Access Compliance Report

Public Rights-of-Way

Intersection ID: 11958	Main Street: E_16TH_ST	Cross Street: SEIGLE_AV	Location: E
ADA ID: 967616DBA6E7	Ramp Type: Perp	Initial Pass/Fail: Fail	Overall Compliance: No
		Severity Score: 1.25

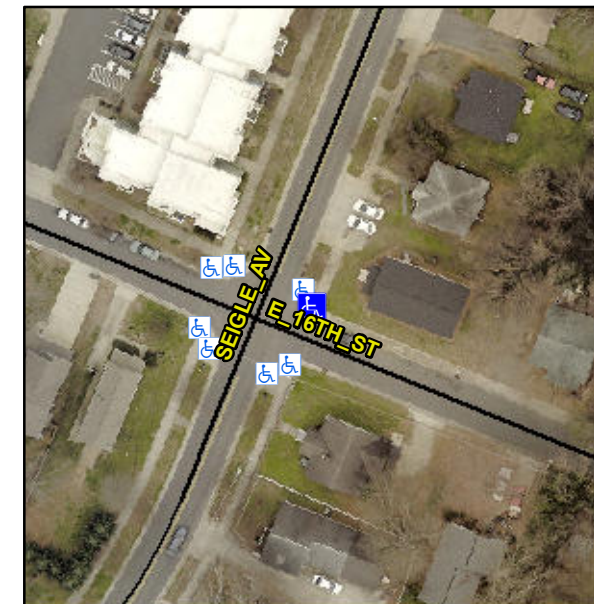
Not Found, R304.5.3

Compliance	Description	Data	Compliance	Description	Data
N/A	Ramp Length (in)	80.0	Yes	Ramp Slope (%)	5.4
Yes	Ramp Width (in)	95.0	No	Ramp XSlope (%)	2.6
N/A	Flare Type LT	N/A	N/A	Flare Type RT	N/A
N/A	Flare Slope LT (%)	N/A	N/A	Flare Slope RT (%)	N/A
N/A	Flare Traversable LT?	N/A	N/A	Flare Traversable RT?	N/A
N/A	Landing Length (in)	N/A	N/A	DWS Provided?	N/A
N/A	Landing Width (in)	N/A	N/A	DWS Contrast?	N/A
N/A	Landing Slope (%)	N/A	N/A	DWS Length (in)	N/A
N/A	Landing X Slope (%)	N/A	N/A	DWS Full Width?	N/A
N/A	Landing Curb? (Y/N)	N/A	N/A	DWS Offset (in)	N/A
N/A	Shared Landing?	N/A			
N/A	Gutter Ponding?	N/A	N/A	Gutter Slope (%)	N/A
N/A	Gutter Lip Ht (in)	N/A	N/A	Gutter X Slope (%)	N/A
N/A	Painted X Walk1?	No	N/A	Painted X Walk2?	N/A
	X Walk 1 Direction	To SW		X Walk 2 Direction	N/A
N/A	X Walk 1 Width (in)	N/A	N/A	X Walk 2 Width (in)	N/A
	X Walk 1 Slope (%)	2.3		X Walk 2 Slope (%)	N/A
	X Walk 1 X Slope (%)	3.2		X Walk 2 X Slope (%)	N/A

Remove & Replace Entire Ramp.
